MAYOR & COUNCIL COMMUNICATION

AGENDA ITEM: Boulder Ponds Preliminary Plat and Preliminary PUD Plan

ITEM: Boulder Ponds – Preliminary Plat and Preliminary PUD Plan

SIGNING/PAVEMENT MARKINGS/LIGHTING NOTES

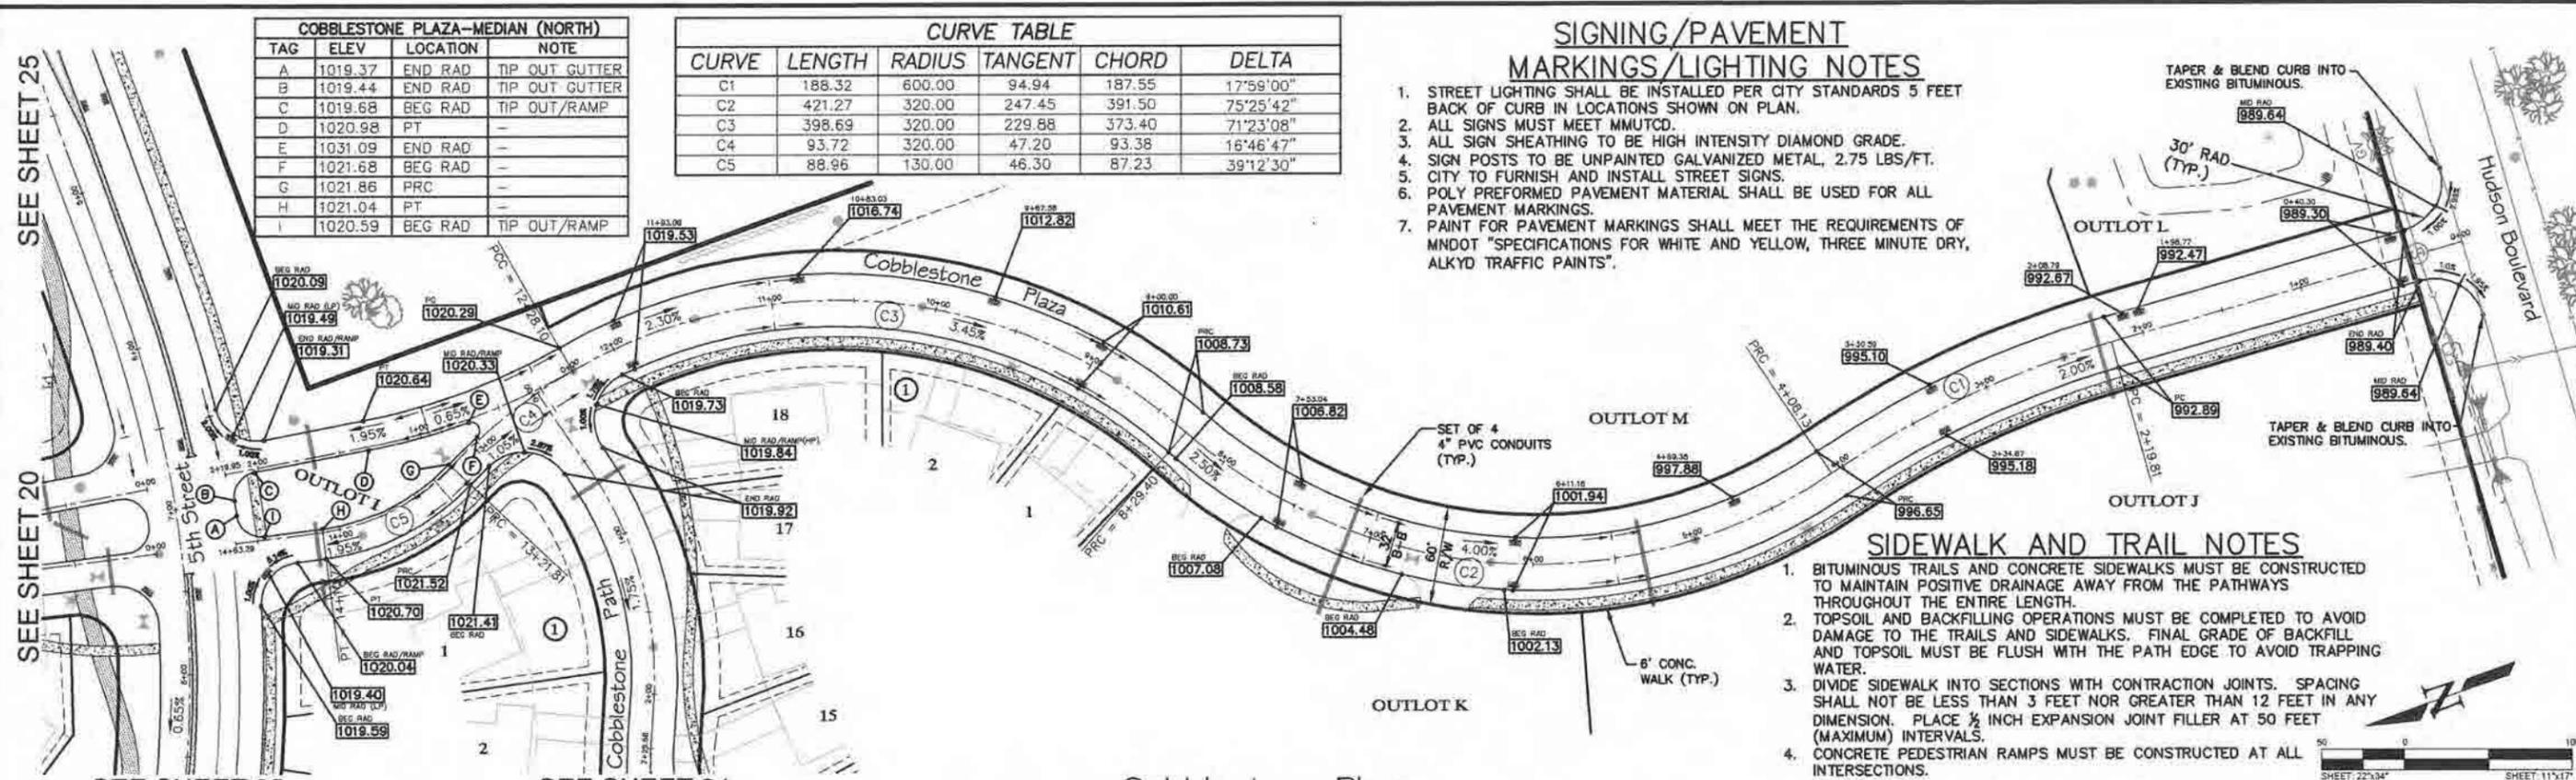
- The signing and striping plan for 5th Street, Sheet SS1, must be updated to meet state aid standards and the 5th Street typical section detail for turn lanes. Signage and pavement markings for cross walks should meet the City standard for cross walk markings.

SHEET NO.
 27 of 28

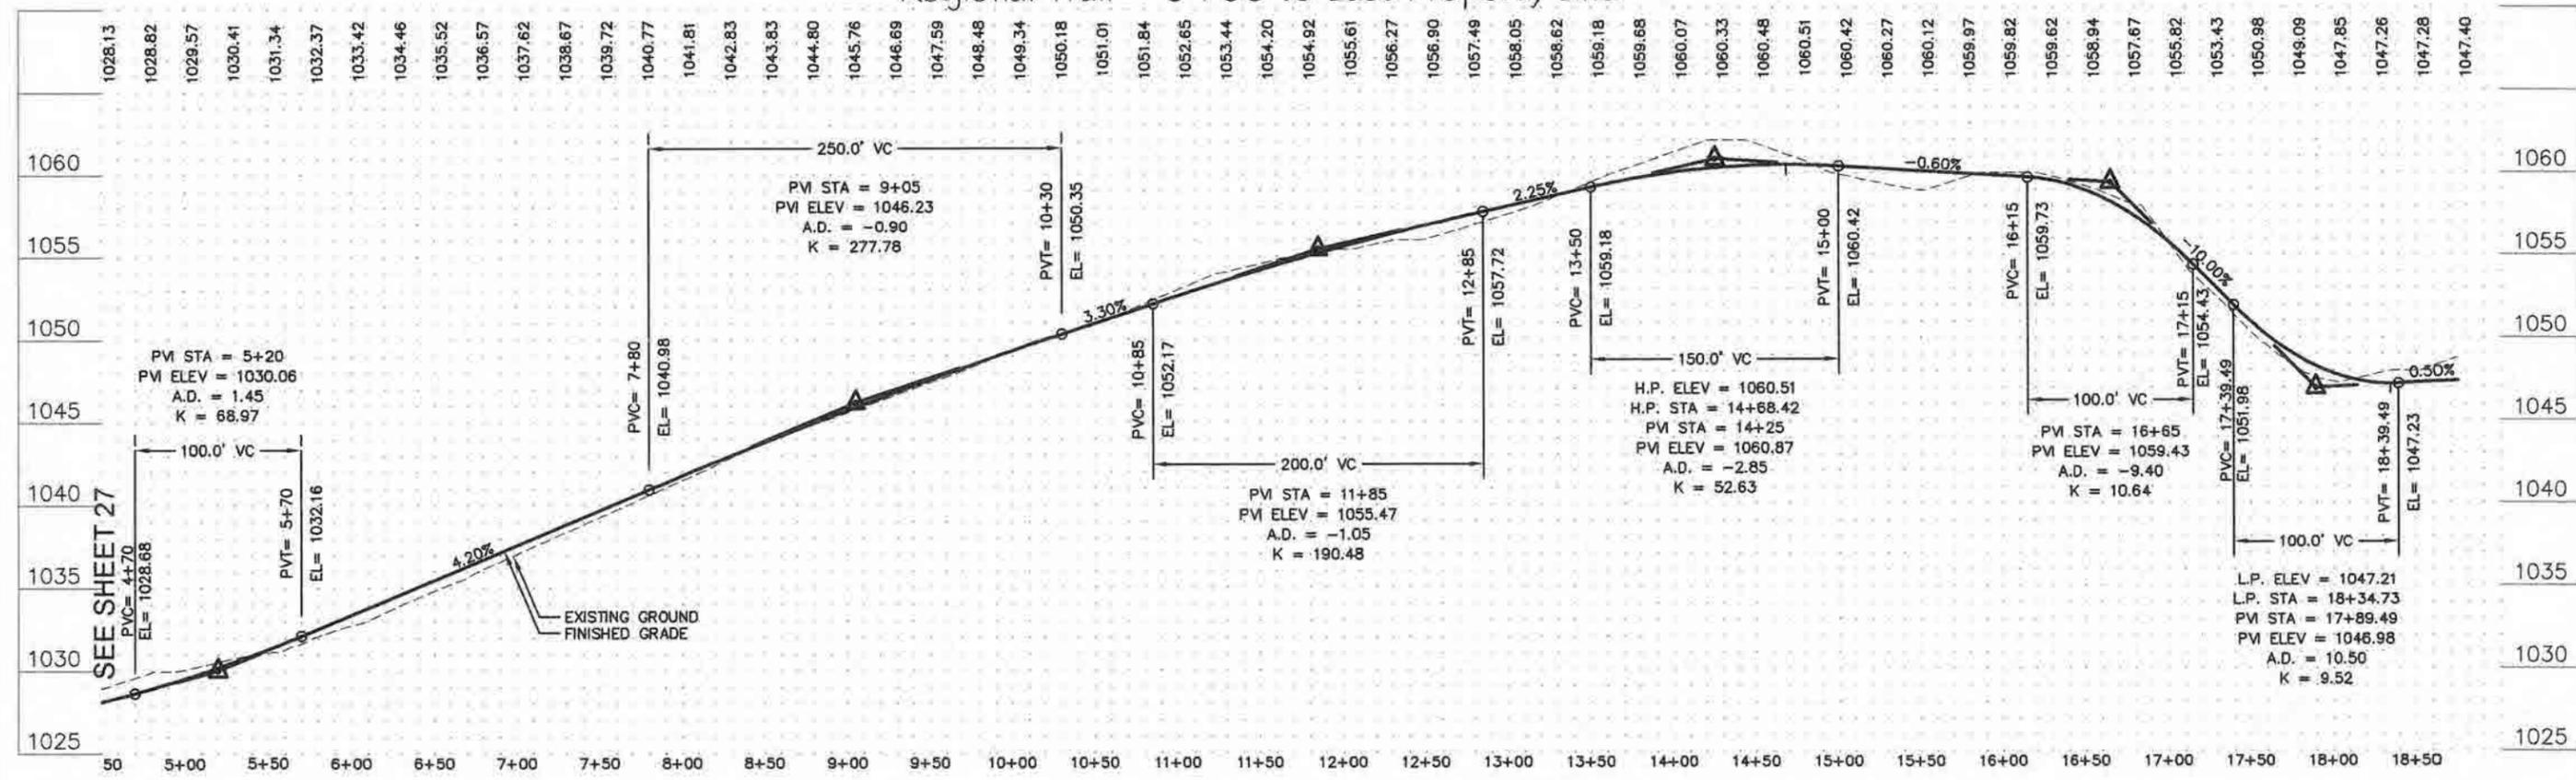
- On Sheet 28 the trail must be revised to maintain a maximum trail grade at 6%. Location to edge of Plat must be coordinated with the Lennar development.
